Request
Project Name
Council District
Requested by

DTC Modifications
Canopy Homewood
19 – O’Connell
Matthew Gower, Overcash Demmit Architects; Anup Patel, Tara of the Gulch LLC;
Hammer
Approve.

Downtown Code DRC Meeting of 01/9/2020

DTC MODIFICATION REQUEST SUMMARY

Figure 7: NES Handbook Diagram

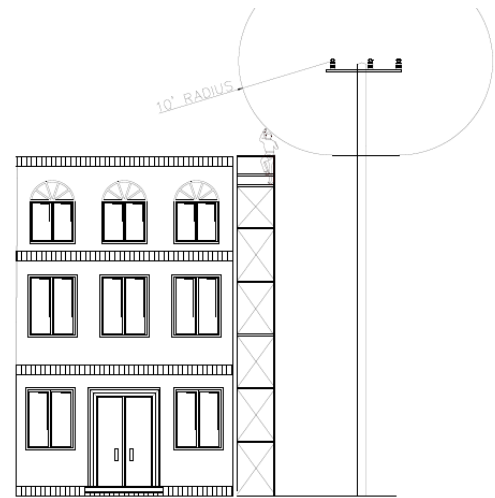
The build-to zone along Overton Street is 0-10 feet from back of sidewalk for a minimum façade width of 60% of the lot frontage. The proposed massing yields a building that is approximately 15 feet from the back of sidewalk for over 60% of the lot frontage. The stated intent of this request is to allow the building to meet OSHA working clearances promulgated by the NES Customer Handbook. In this case, there are existing power lines on both Division Street and Overton Street.

Figure 8: Building Massing at Division Street Frontage

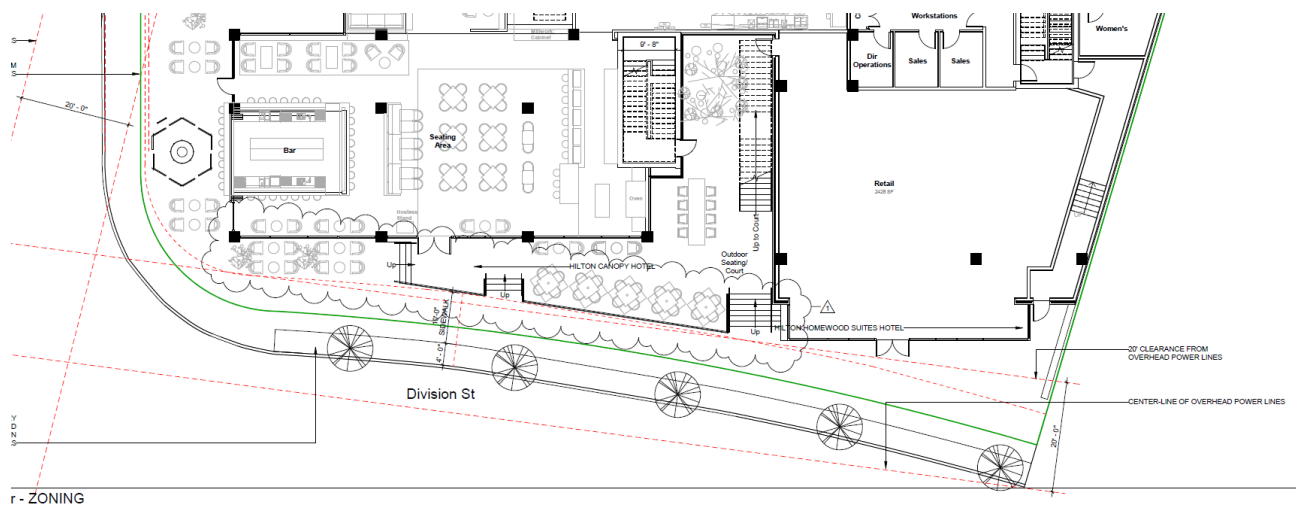
The build-to zone along Division Street is 0-10 feet from back of sidewalk for a minimum façade width of 80% of the lot frontage. In this case, while portions of the building are within the build-to zone, the minimum façade width is approximately 52% of the lot frontage. Like the condition on Overton Street, Division Street is also encumbered by power lines and the massing has been articulated in a way that avoids the life-safety issue described previously. The remaining 48% of the lot frontage will be programmed and activated exterior space, with outdoor seating and seating proposed. Due to the activity proposed along this façade and the exterior dining areas, we find that the frontage is appropriately activated and recommend approval of this modification.

Figure 9: Division Street (Left) and Overton Street (Right) Sections

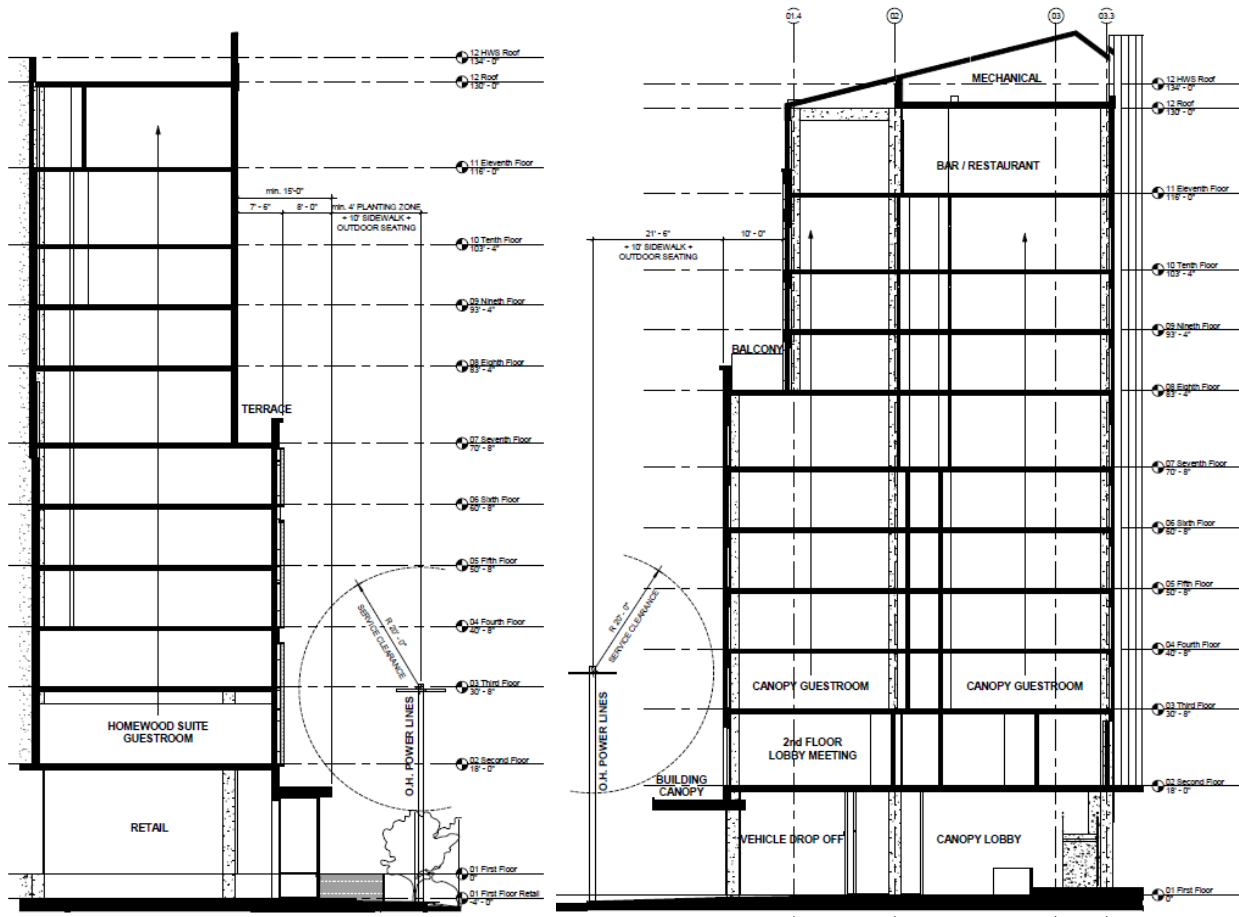
The DTC requires buildings seven stories or greater to step back 15 feet between the fourth and eighth stories. The step-back is measured from the façade of the building. The project proposes stepping back 10 feet on Overton, rather than 15 feet. Along Division, the building steps back 7' at the 2nd story and 8' at the 7th story.

The intent of the step-back standard is to allow light and air to permeate to the street by pushing upper levels of the building back from the street. In this case, the proposed massing yields an equivalent effect on light or air permeating to the street. On Overton Street, rather than being built at 10 feet from the back of sidewalk with a 15-foot step-back, the building is proposed at 15 feet from back on sidewalk with a 10-foot step-back. On Division Street, the step-back is broken up, with a 7' portion of the step-back occurring at the 2nd floor (as opposed to the 4th floor) and the remainder of the step-back occurs at the 7th story. Both of these fulfill the basic intent of the standard in the context of the encumbrances along these frontages. Taking into consideration the merits of the massing and the intent of the step-back standard, staff is supportive of this modification.
